- RGC REPORT NO 111001/7

## **DAM INSPECTION – December 2007**

- **TAILINGS DAM REVIEW BOARD REPORT NO 7**
- **MARLIN PROJECT, GUATEMALA**

Prepared by Dr. Andrew M. Robertson P.Eng.

**Photo 12 – Large boulders and sand fines in rockfill**

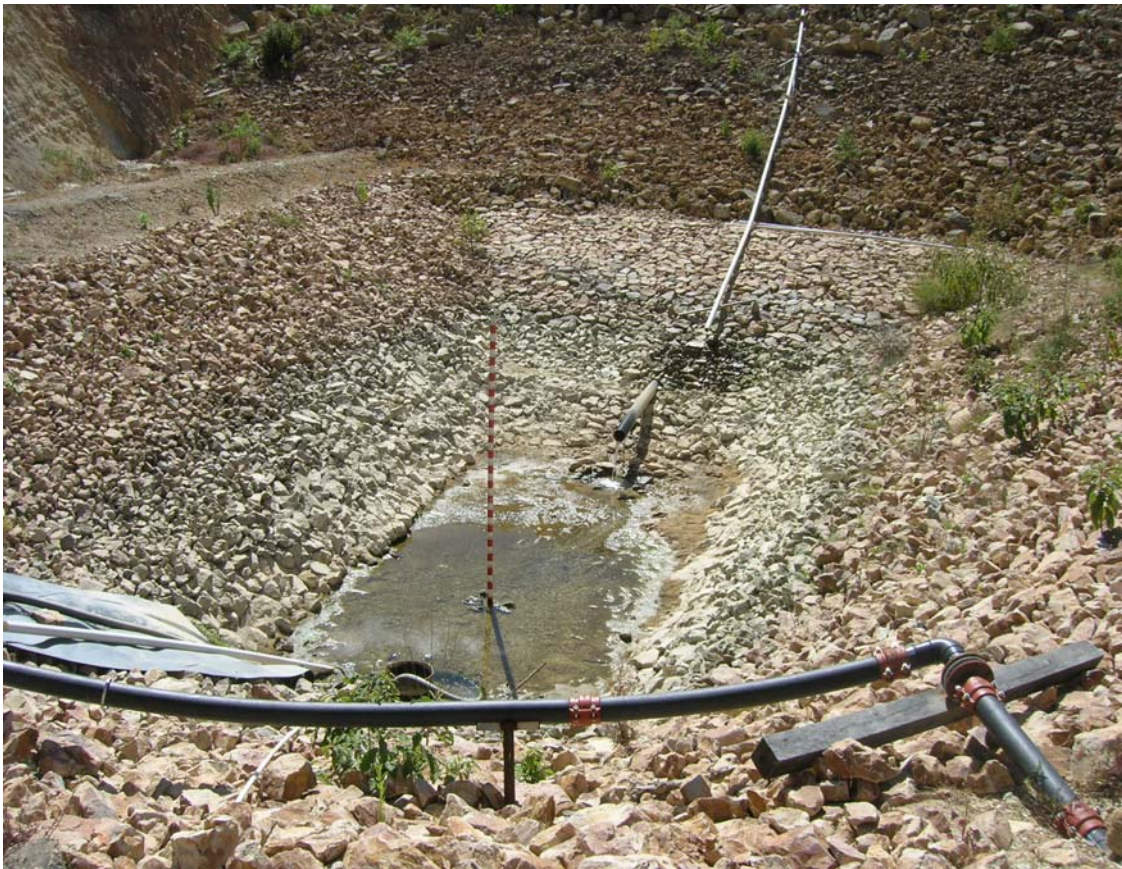
Some rock fill is very poorly graded, large boulders with sand (Photo 12). More selection at quarry recommended. Lifts appeared in excess of 1 m specified (Photo 12). *More care in fill layer thickness is needed.*
